Shanta Denims Limited (Extension)

17 December 2024

Structural Inspection Report

Observation 1: Lack of information in the design report. (New Production Building).

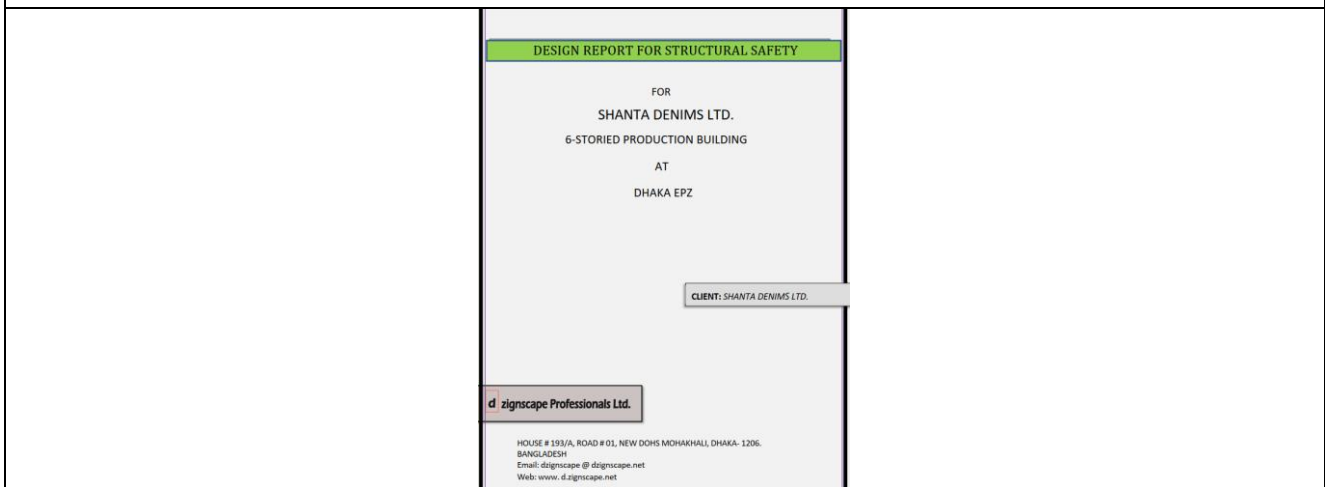
Description: In the design report (as per BNBC-2020), the framing system is not defined. The value of the response modification factor (R) is considered as 5 without any calculation and justification. The building engineer is required to update the design report as per 1.9.1-BNBC and submit it to RSC for review.

Observation-2: Discrepancy and missing information in as-built drawing (New Production Building).

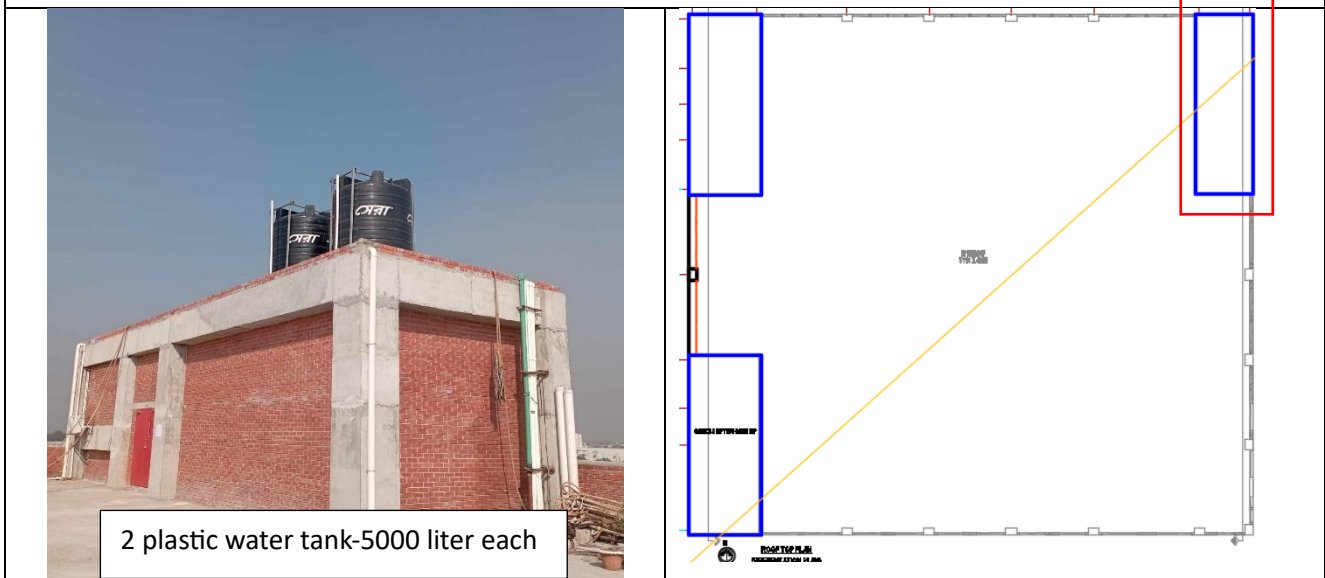
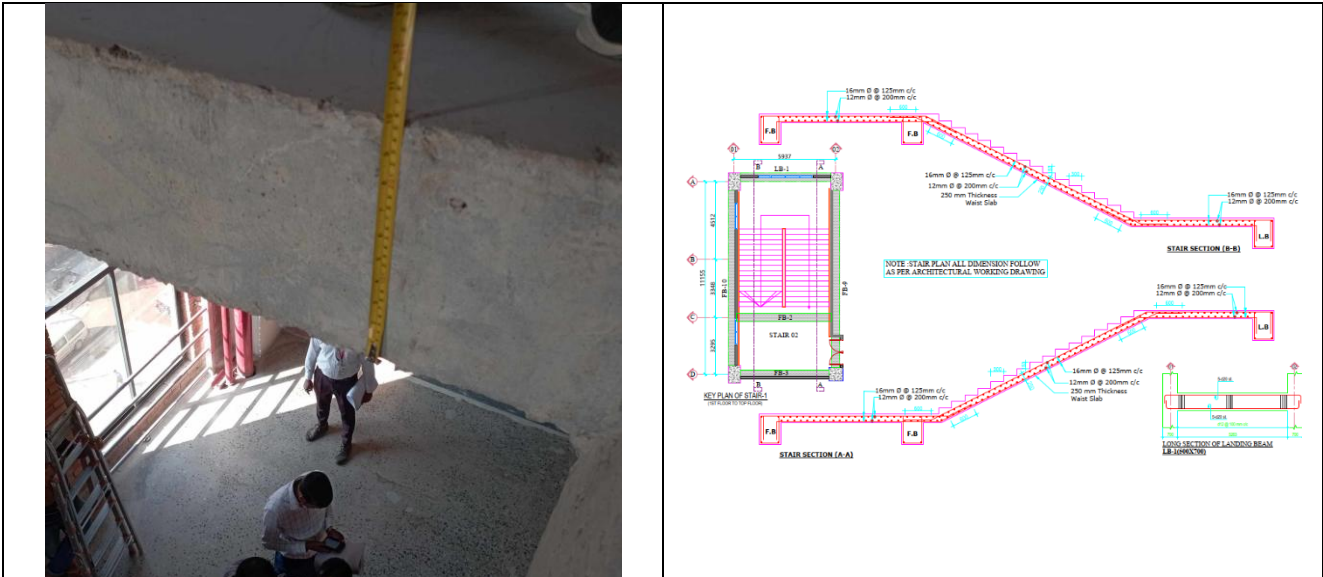
Description: 2 plastic water tanks-(5000 liters each) were observed on the stair op slab but not shown in the as-built drawing. The building engineer is required to update the as-built drawing.

Description: Slab thickness of landing slab is not shown in the as-built drawing. The building engineer is required to update the as-built drawing.

Observation 3: Possibility of vehicle impact (New Production Building).

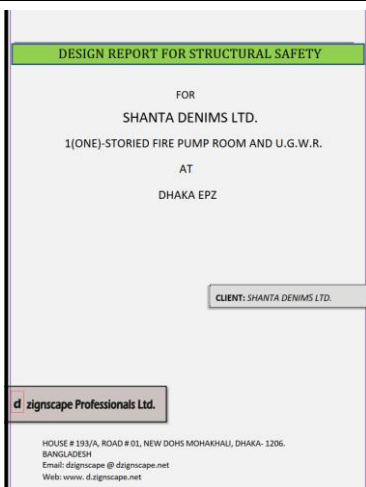
Description: Exposed columns were found prone to vehicle impact. The building engineer is required to provide a barrier to the exposed column to avoid vehicle impact.

Observation-5: Lack of load plan and information in the design report (Fire pump room-2).

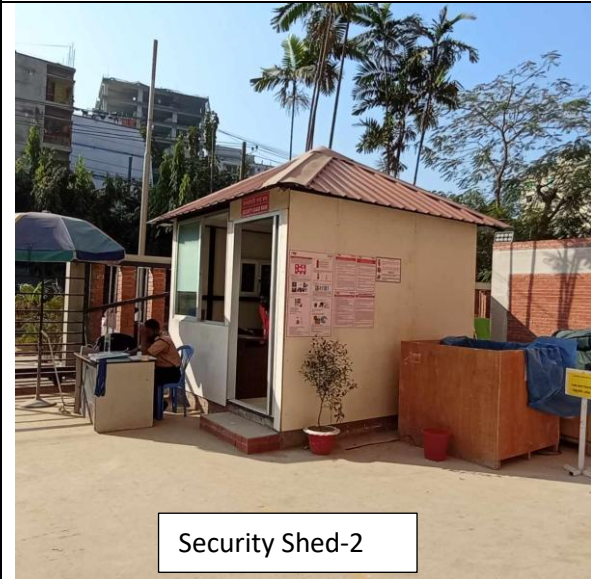
Description: No load plan was available for the structure (parking area over water tank). The value of response modification factor (R) is considered as 5 without any calculation and justification. The building engineer is required to update the design report as per 1.9.1-BNBC and submit it to RSC for review.
